- 2. Brown's Acres Estates; KPB File 2022-088**
Peninsula Surveying, LLC
Anchorage Development & Construction, LLC
Sterling Area

PLAT OF
BROWN'S ACRE ESTATES

KPB File No.	2022-088
Plat Committee Meeting:	July 18, 2022
Applicant / Owner:	Anchorage Development and Construction LLC of Anchorage, Alaska
Surveyor:	Jason Schollenberg / Peninsula Surveying, LLC
General Location:	Foster Avenue, Sterling

STAFF REPORT

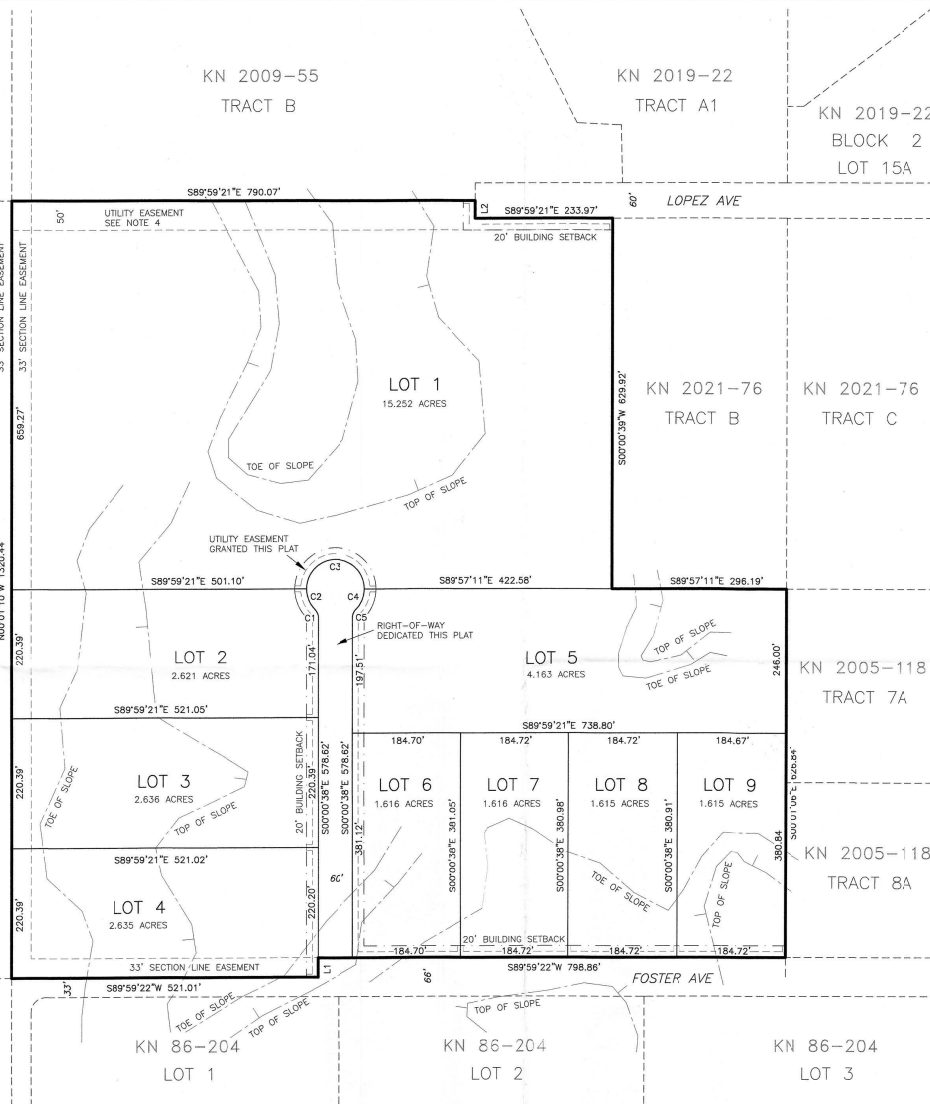
Site Investigation: There are some small low wet areas present in the southwest corner and along the eastern portion of the subdivision. **Staff recommends** the low wet areas be depicted on the final plat and a Corps. of Engineers plat note be added.

There are steep slopes present throughout the property. The toe and top of slopes are depicted on the plat. **Staff recommends** the depictions of slopes remain on the final plat.

Along the north is the depiction of a 50 foot wide utility easement and a reference to plat note 4. The document noted in note 4 is vague on the description and does state that it is for down guy and anchor. Homer Electric Association is requesting that the depiction be removed and plat note 4 be updated to state the location is not defined.

HEA	Remove the 50 foot offset line depicting a utility easement. The easement of record is for a down guy and anchor that extends 50 feet from the north property line. HEA is not able to determine the location of the down guy and anchor. Revise plat note 4 to state that the location is not defined. Depict and label the 10 foot utility easement as granted per KN 85-49
ENSTAR	No comments or recommendations
ACS	No objections
GCI	Approved as shown

- C. The location, width, and name of existing or platted streets and public ways, railroad rights-of-way, and other important features such as section lines or political subdivisions or municipal corporation boundaries abutting the subdivision;
Staff recommendation: KPB information indicates that the section line easement adjacent to the western boundary is 50 feet in width. Please verify the width and if the easement is 33 feet in width please provide documentation to the KPB.

- D. A vicinity map, drawn to scale showing location of proposed subdivision, north arrow if different from plat orientation, township and range, section lines, roads, political boundaries, and prominent natural and manmade features, such as shorelines or streams;
Staff recommendation: Include the Soldotna City Limits.

- F. The location, width and name of existing and platted streets and public ways, railroad rights-of-way, easements, and travel ways existing and proposed, within the subdivision;
Staff recommendation: An approved name will be required, please contact the KPB Addressing Officer

Staff recommendation: *The new dedication appears to be within an area with suitable slopes. However, the applicant is requesting exceptions to not dedicate additional rights-of-way due to terrain. Staff will recommend center line profiles for Foster Avenue to show that the right-of-way to connect to the new dedication can be built to borough standards and additional slope easements or dedications of width may be required along Foster Avenue to the newly proposed dedication.*

Staff recommendation: *Once the street name is approved it should be added to the Certificate of Acceptance. Any other dedications that are determined to be required shall be added to the statement.*

- *Any person developing the property is responsible for obtaining all required local, state, and federal permits, including a U.S. Army Corps of Engineers wetland determination if applicable.*
- *Add a note for any exceptions granted.*
- *Additional plat note may be required in regards to a utility easement depicted on the parent plat.*

Plat note 4 should include "No definite location"
